RE: **Lot 4 Block 6 Unit 18, S.A.D. 228**  
**Volcano Cliffs Subdivision**  
**6616 Kimmick Rd. NW**  
**Grading and Drainage Plan**  
**Engineers Stamp Date; 7-27-19 (D10D003M4)**  
**Pad Certification Date; Not provided**

Based upon the information provided in your submittal received 12/13/19, this plan cannot be approved for pad certification until the following comments are addressed.

CANDELARIA - GONZALES - GRADING & DRAINAGE PLAN

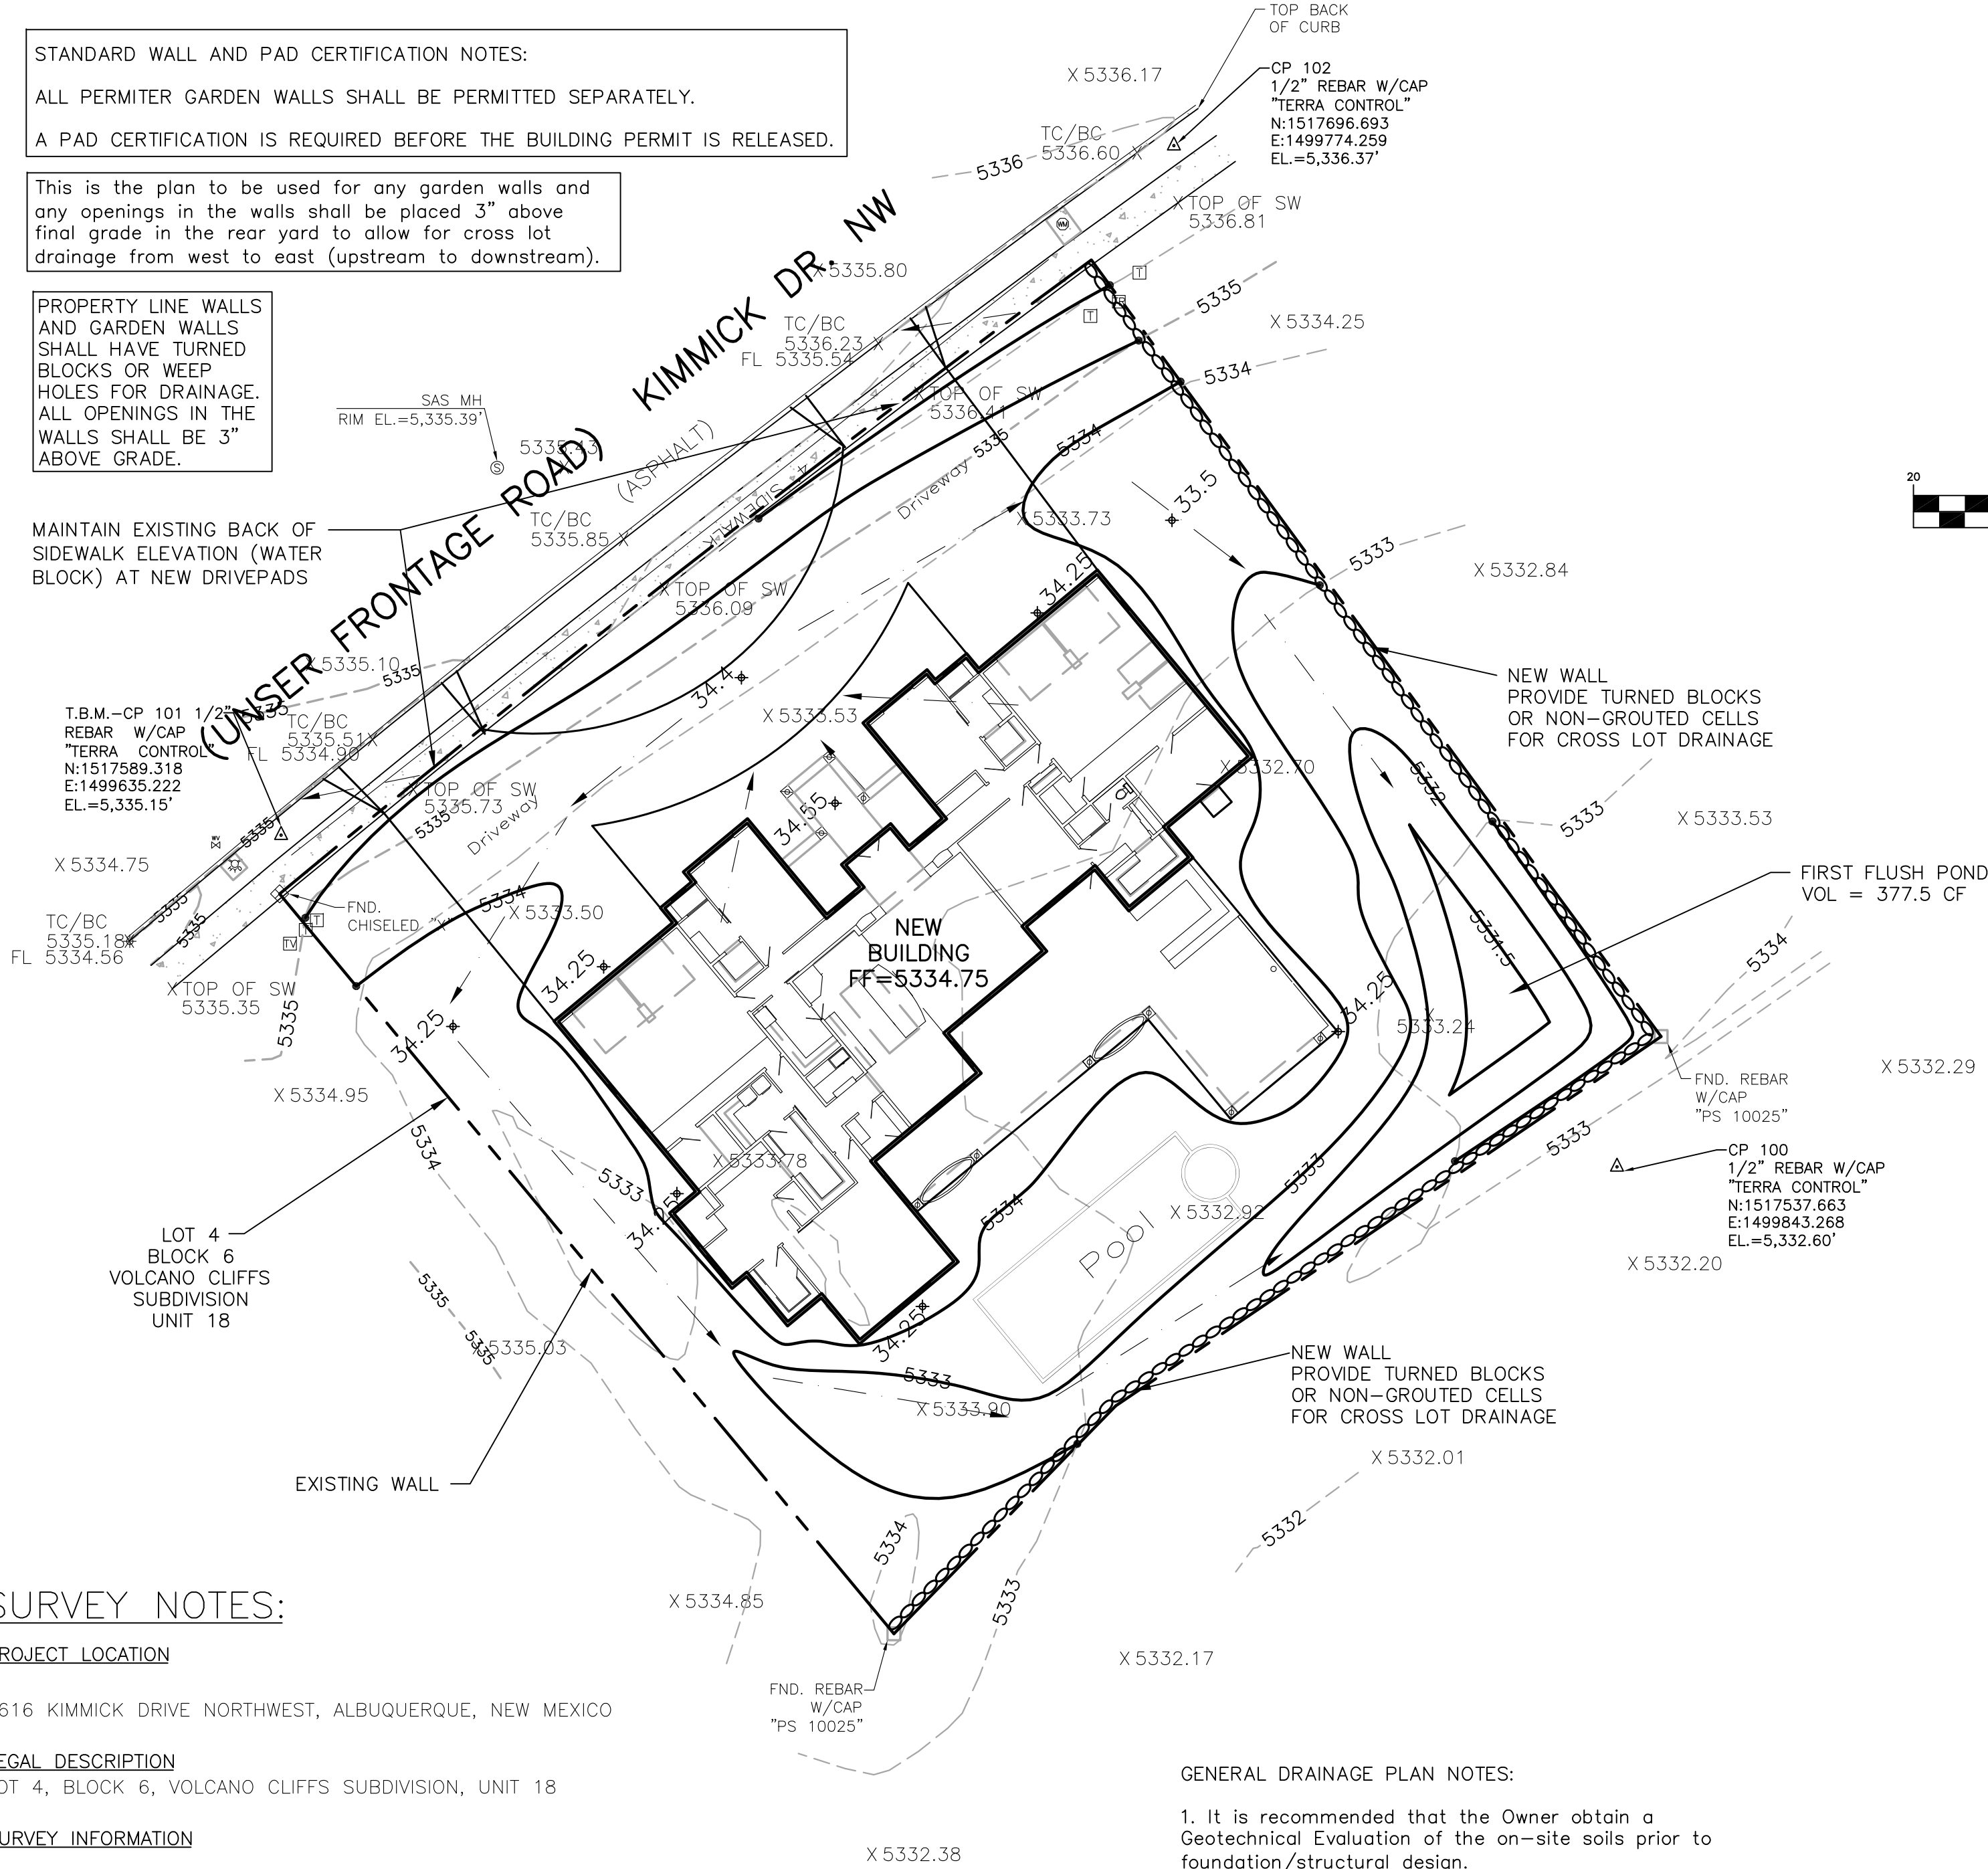
- Provide the Pad Certification language, sign and date.
- Building pad not present. Make a site visit before asking for pad certification.
- Have all dirt and debris removed from the public right of way. Make sure they sweep the street and sidewalk.
- Provide the percent amount of land treatment C.
- Provide an accurate amount of land treatment D. Include the amount around the pool area. This may increase the amount of precipitation to be held on site.
